ENCLOSURE

SAFETY EVALUATION REPORT ON
XN-NF-82-07, REVISION 1

"EXXON NUCLEAR COMPANY ECCS CLADDING SWELLING AND RUPTURE MODEL"

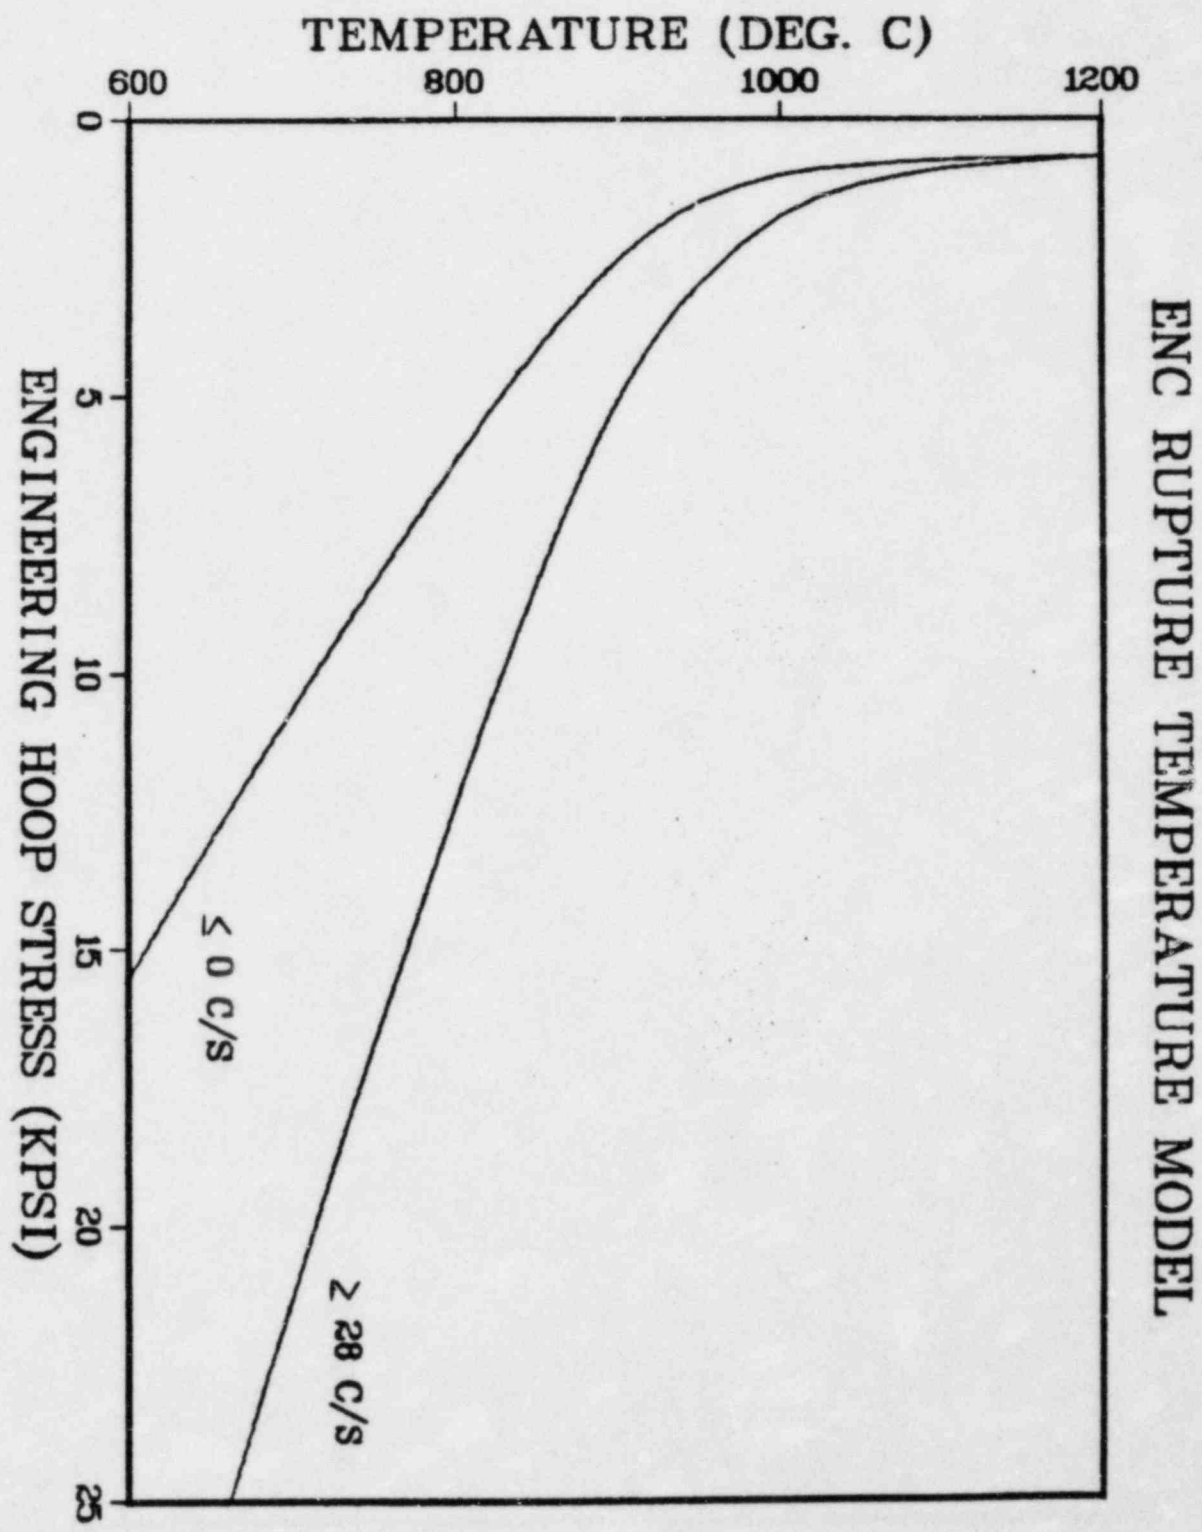
The new ENC model for predicting the occurrence of LOCA-induced cladding rupture is shown in Figure 1. The two curves that are depicted in Figure 1 represent the boundary limits of the model, which are associated with cladding temperature ramp rates of 0 and 28°C/s. A family of intermediate curves (not shown but available from the use of an equation in Section 3.2 of the report) is used to predict failure at ramp rates between 0 and 28°C/s.

At rupture temperatures below 950°C, Exxon has adopted the rupture temperature correlation described in NUREG-0630. At rupture temperatures above 950°C, Exxon has used newly acquired data (Refs. 5, 6, 7, and 8) to develop a ramp-rate dependent extension to the low-temperature portion of the model. The high and low segments of the rupture temperature model merge smoothly at the transition temperature of 950°C. The high-temperature portion of the model is less conservative than the NUREG-0630 correlation; however, it more closely fits the available data base. (See Figure 3.2 in XN-NF-82-07, Revision 1 or Figure 2 of a recent SER given in Reference 10 for comparisons of the new high-temperature data to the new Exxon model and the similar General Electric model.)

The new ENC model is acceptable inasmuch as it does not underestimate the incidence of cladding failure.

Figure 2

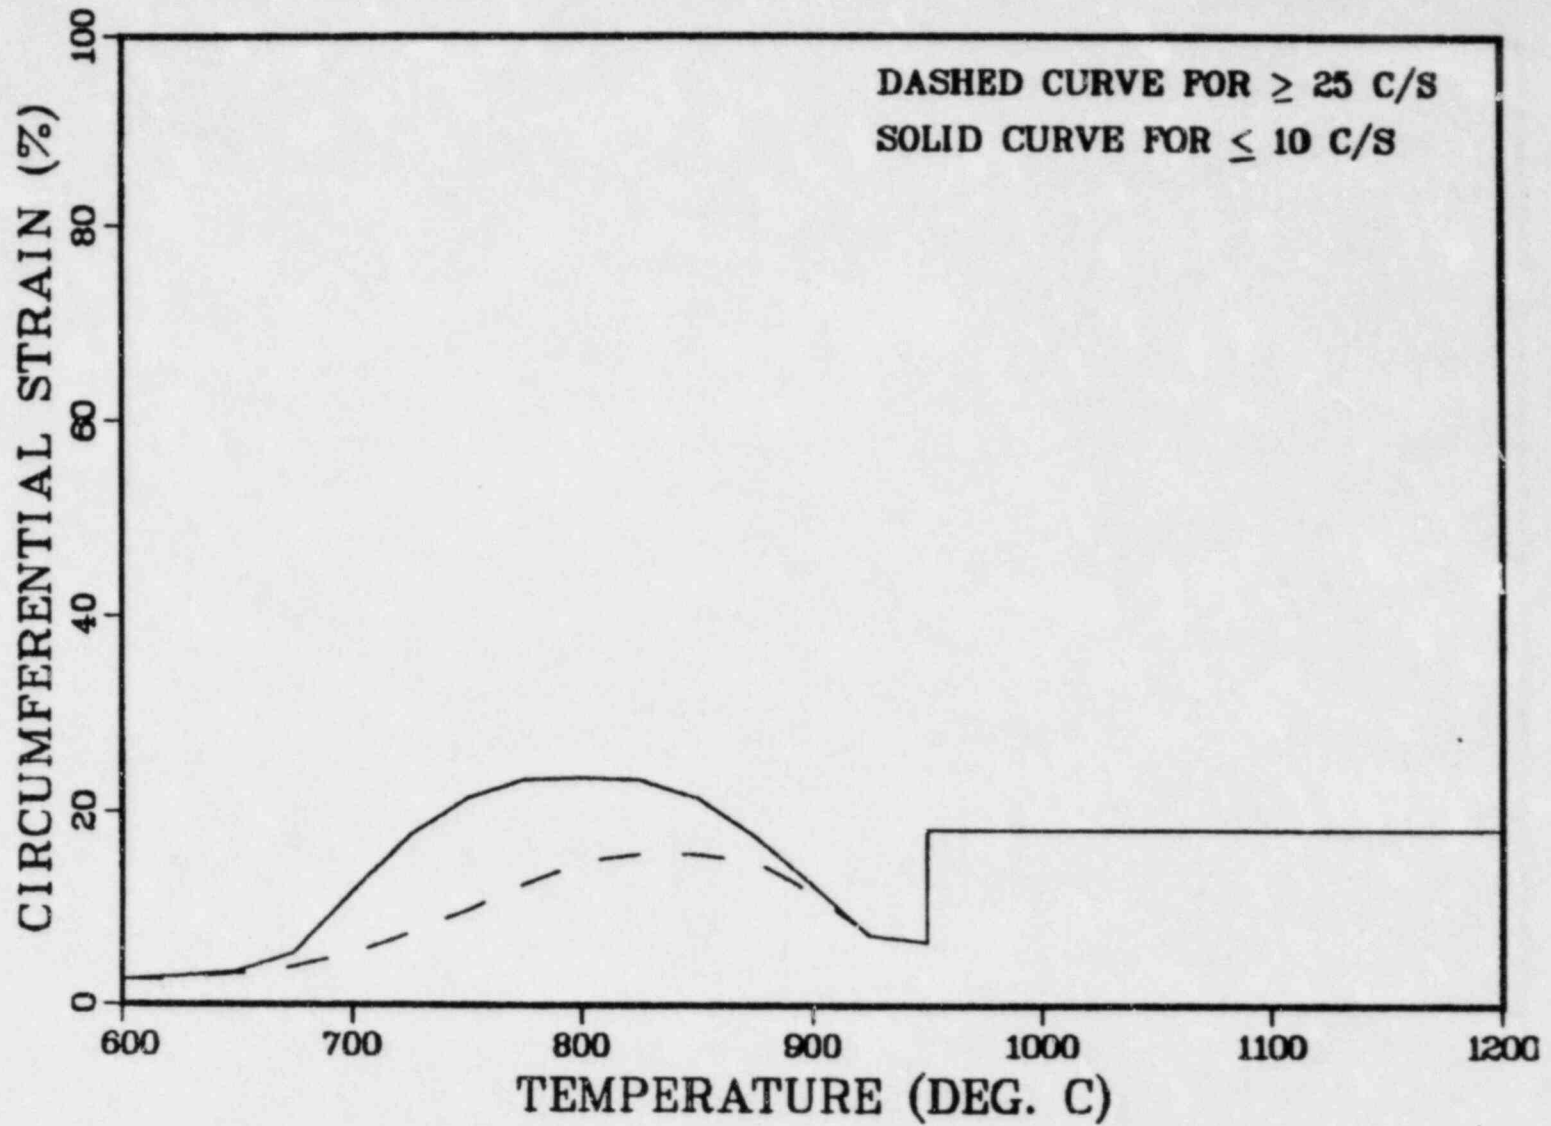
Exxon calculates prerupture plastic strain in a standard fashion similar to that described in WREM (Ref. 11). Based on experimental results by Hardy (Ref. 12), non-elastic swelling commences 111°C below the predicted rupture temperature at a given cladding wall hoop stress and exponentially increases with further increases in temperature. The model (a) does not account for the potential of creep rupture (i.e., failure at stresses less than the ultimate tensile stress) and (b) analytically limits prerupture plastic strains to a fraction of the affiliated burst strain. Figure 2 depicts the maximum degree of prerupture strain in the ENC analysis. As shown in Figure 2 (and the

subsequent strain and blockage Figures 3-6), the dashed curve is applicable to ramp rates greater than or equal to 25°C/s whereas the solid curve is applicable to ramp rates less than or equal to 10°C/s. Linear interpolation is used for intermediate ramp rate applications.

The pre-exponential coefficient in the original ENC PWR model was modified in the ENC report XN-76-51 (Ref. 13) to obtain better agreement with experimental data from the Multirod Burst Test Program at ORNL. This modified model has not been further changed in XN-NF-82-07, Revision 1 and it thus remains acceptable.

In addition, ENC has incorporated the prerupture strain model into the HUXY code thus improving the realism of the BWR LOCA analysis. The inclusion of prerupture strain consideration into HUXY necessitated a reduction in the bulging probability constant, which is employed in the stochastic treatment of BWR cladding ballooning and failure. Specifically, the bulging probability is the ratio of the number of failed rods in the plane of maximum blockage to the total number of failed rods in the bundle. Inasmuch as the previous version of HUXY did not account for prerupture strain, the probability of rupture occurring in the plane of interest had been artificially set to a value of 83.8% - - a value which provided a psuedo-agreement with the Zircaloy-2 FLECHT experiment (Ref. 4). The revised bulging probability as directly calculated from Reference 4 is 61.5%.

The term bulging probability is somewhat of a misnomer now that prerupture strain is an integral part of the ballooning analysis, and the term rupture probability would be more appropriate. Notwithstanding, the prerupture strain modifications to HUXY are clear improvements and are acceptable.

Figure 3

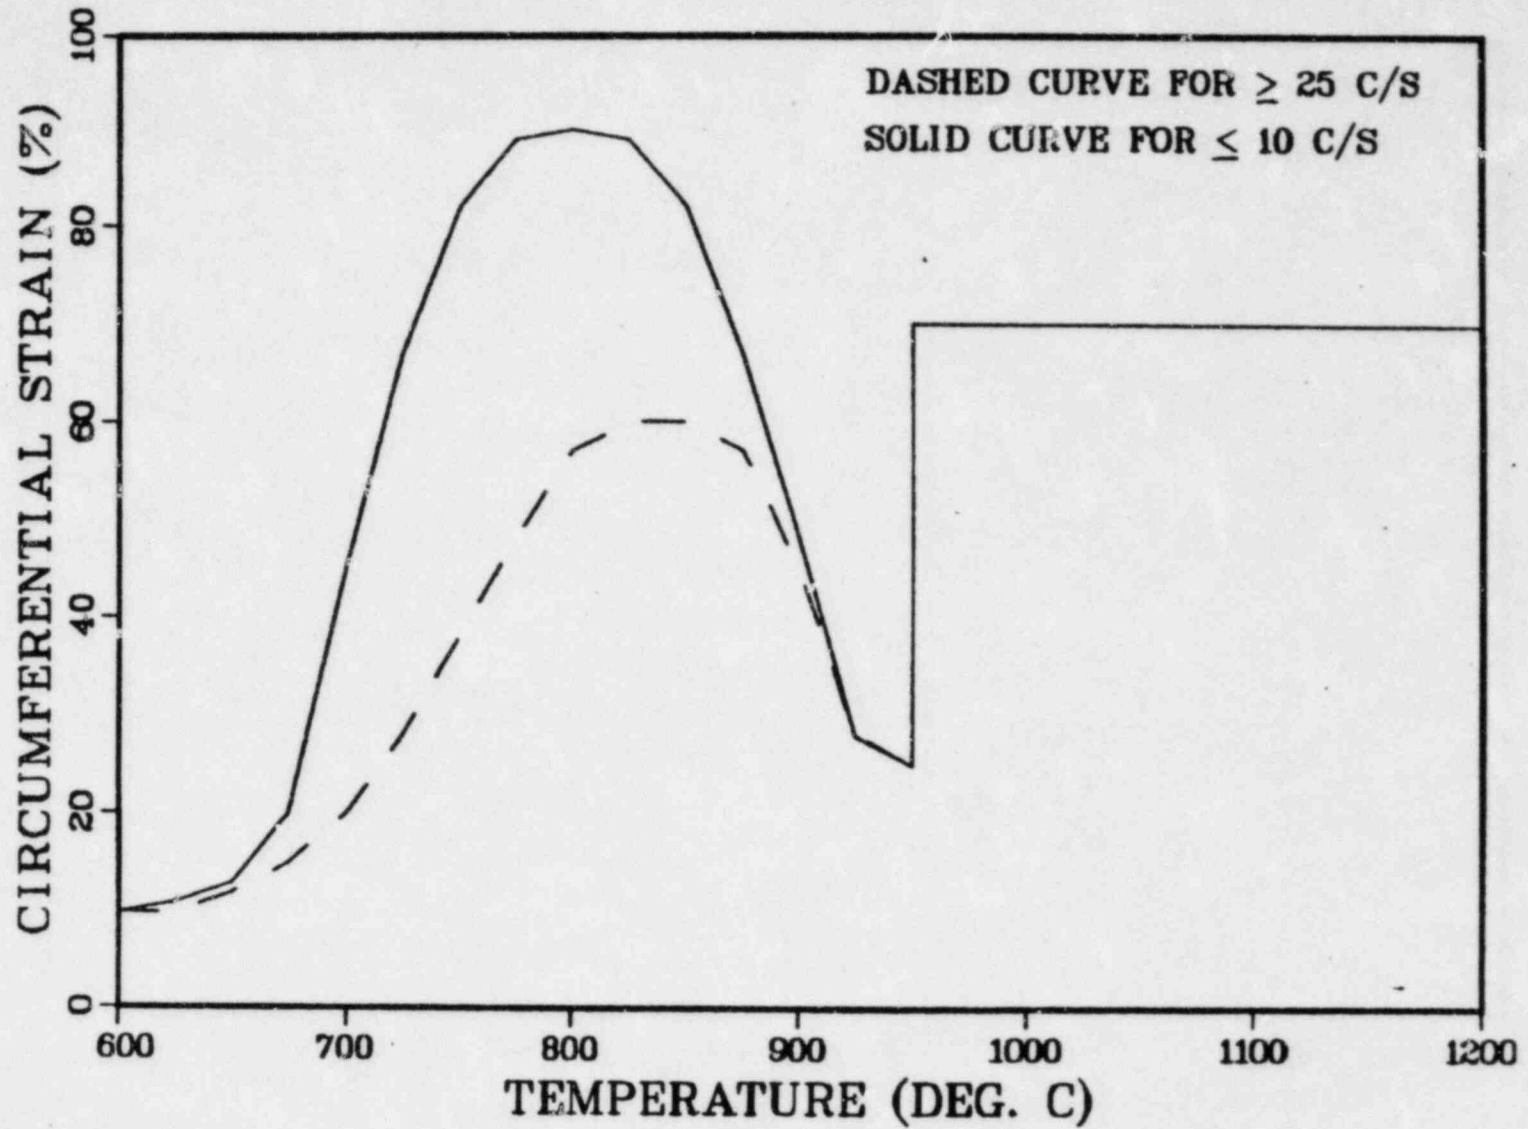
The first burst strain model, as shown in Figure 3, is actually a hybrid model. For rupture temperatures below 950°C, Exxon has adopted the burst strain correlation described in NUREG-0630. For rupture temperatures above 950°C, Exxon has used newly acquired data (Refs. 5, 6, 7, and 8) to develop a new high-temperature portion of the model. At temperatures below 950°C, the model is temperature ramp rate dependent. Figures 6 and 7 of NUREG-0630 and 4.2 of XN-NF-82-07, Revision 1 provide comparisons of these models to the available data base.

We conclude that the ENC burst strain model shown in Figure 3, is acceptable because it does not underestimate the degree of swelling.

Figure 4

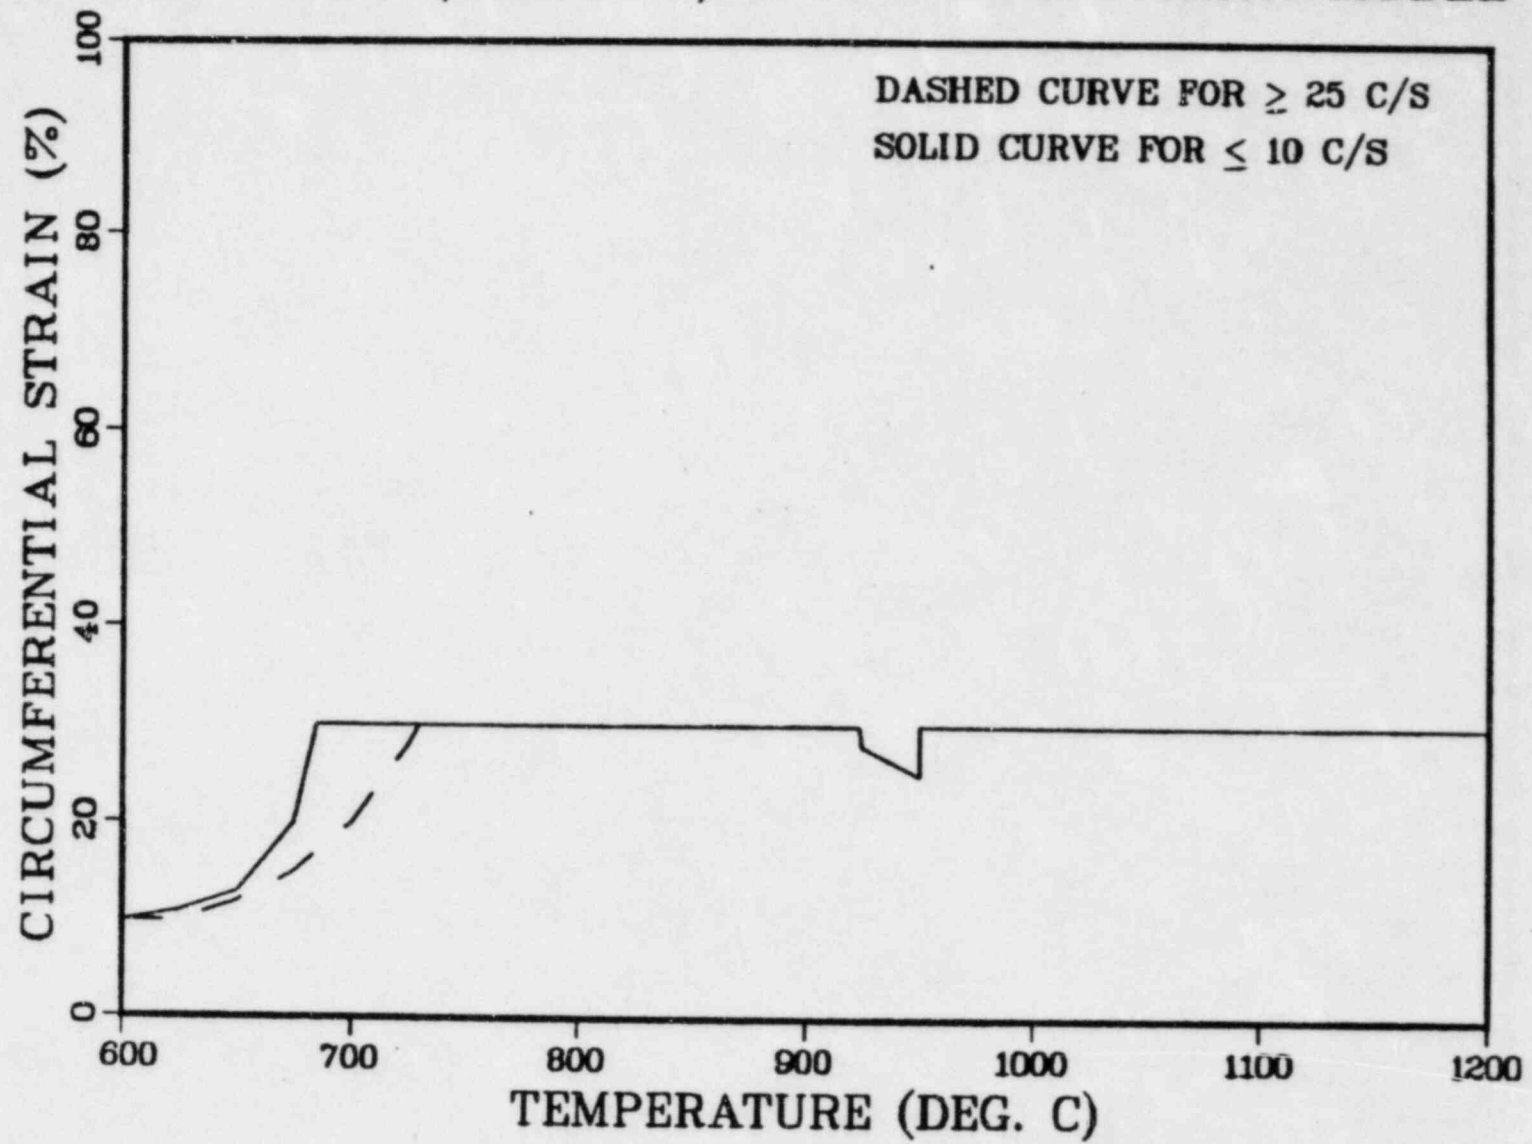
As shown in Figure 4, the first ENC HUXY model for general BWR calculations (i.e., surface heat transfer area, radiation view factor, and gap conductance after rupture) is a truncated version of the model shown in Figure 3. The truncation is at a strain level where a swollen fuel rod's diameter would equal the design fuel rod pitch (i.e., about 30%). Limiting strain in this manner mathematically simplifies the radiation heat transfer calculations. Similar unnatural limitations are imposed in counterpart ECCS evaluation models (see, for instance, the General Electric model described in Reference 10 or the MOXY model described in Reference 14). In support of this model, Exxon has (a) stated that the average burst strain in the FLECHT tests was only 34.5% and (b) provided the results of LOCA sensitivity studies that exemplify the inconsequential effect of this strain artificiality.

Those sensitivity studies were performed on an 8x8 BWR assembly in which 4 center rods were allowed to rupture in the plane of interest. For one case, the strains were 20%; for another case, the strains were 32%. The new result of the calculations was that the case with the higher strains yielded 7°F lower peak cladding temperature (PCT) and 0.3% higher local cladding oxidation (LCO).

These results are understandable in light of the competing effects that are operative; that is, increases in strain create (a) increases in convective and radiation heat transfer, (b) decreases in gap conductance, and (c) increases in metal-water reaction heat. The latter variable will increase PCTs while the former two will decrease PCTs.

As discussed in Reference 10, a higher coplanar strain of 40% would perhaps be more appropriate to assess than strain to rod pitch, but nevertheless the impact of strain on PCT and LCO is clearly in the same direction and of the same magnitude as that calculated by General Electric (Ref. 10) and evidently of relatively little significance. Consequently, we approve the ENC strain model used for BWR general calculations not on the basis of its realism but because the PCT and LCO are sufficiently insensitive to variations in cladding strain.
